**Agenda Item: Plat - Preliminary**

Title: Mountain West Estates Subdivision: A preliminary plat for eight lots out of a parcel of land 40.35 acres in size.

Re: Site Specific Investigation
Mountain West Estates Subdivision
Technical Review – Revised Plat

Date: August 4, 2015
To: City Council
From: Charles Bloom, AICP, Senior Planner
Subject: PP-15-02 Mountain West Estates Preliminary Plat

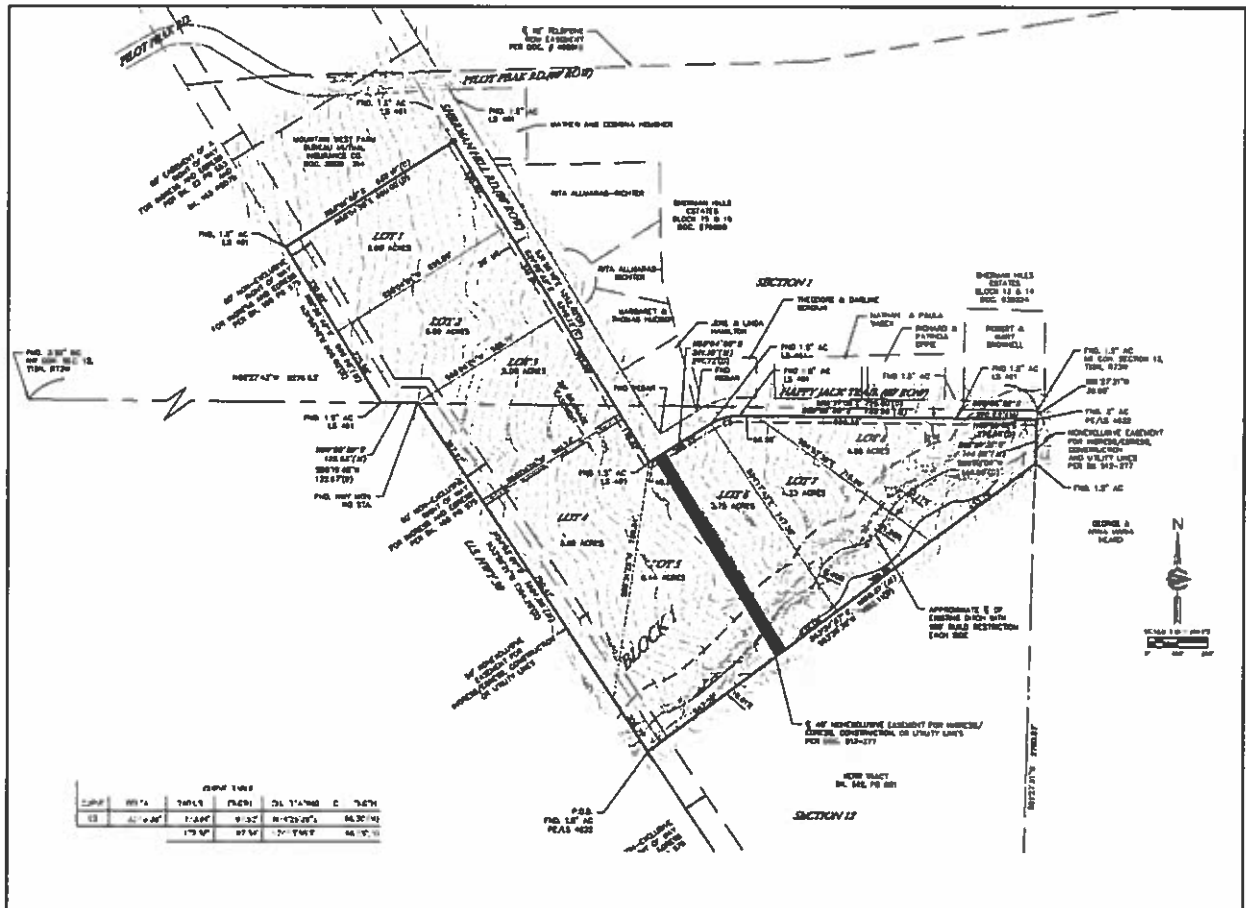
This letter serves to present the findings of our technical review of the site specific investigation prepared by Weston Engineering, Inc. (Weston) and presented to Albany County for the proposed Mountain West Estates Subdivision located within the Casper Aquifer Protection Area. This review was specific to the potential impacts to the Casper Aquifer from the revised plat which was modified to address the ingress/egress/construction/utility easement located between the revised lots (Block 1, Lot 5 and Block 1, Lot 6) (See Figure Below).

The proposed ingress/egress easement crosses the one vulnerable feature that was identified within the setback distance of the development area. This is an ephemeral drainage located along the eastern boundary of the proposed subdivision. As addressed in the site specific investigation prepared by Weston, mitigation of the potential impacts of this vulnerable feature to the Casper Aquifer were addressed by identifying and incorporating a "build restriction" area 100 feet on each side of the drainage centerline. This building restriction zone, along with the ephemeral drainage's location along the eastern boundary, will limit the subdivision improvements to be constructed down gradient from this drainage. In the original plat, access to the proposed development across this ephemeral drainage would have taken place along established roads and, therefore, the only increased risk of contamination to the Casper Aquifer via this ephemeral drainage would have been the slight traffic increase imposed by the addition of these eight residential lots.

The development of the proposed Mountain West Estates Subdivision will have no bearing on the potential risk to the aquifer due to the location of this easement. This easement was in place prior to the proposed development of the subdivision. If the owner of the easement wishes to utilize and improve the surface conditions to allow vehicles to travel across the critical drainage, then the burden of protection of the Casper Aquifer will be placed upon the easement owner to demonstrate the proper protection of the aquifer, when and if, this easement is utilized.

With respect to the development of the Mountain West Estates Subdivision, the location of this easement will not increase the risk to the Casper Aquifer. With respect to the increased potential of risk to the aquifer if a road were constructed across this drainage, we do not feel that there is an increased risk to the aquifer. Utilization of this road would essentially just transfer the same level of risk of a vehicle traveling across the drainage from the crossing at Happy Jack Trail to the easement roadway. The number of vehicles crossing the drainage would remain the same whether the Kerr easement road was in place or not, therefore, the level of risk from vehicle traffic would remain the same. The area of dust control would increase, but the typical product for dust control is magnesium chloride which does not pose a threat to the quality of the Casper Aquifer. The levels of chloride in the Casper Aquifer are quite low, less than 10 mg/l. EPA's Secondary Drinking Water Standard for chloride is 250 mg/l, therefore, due to the limited area of road exposure crossing the drainage and the very low intrinsic levels of chloride, the application of a magnesium chloride dust suppressant will not pose an increased risk to the quality of the Casper Aquifer.
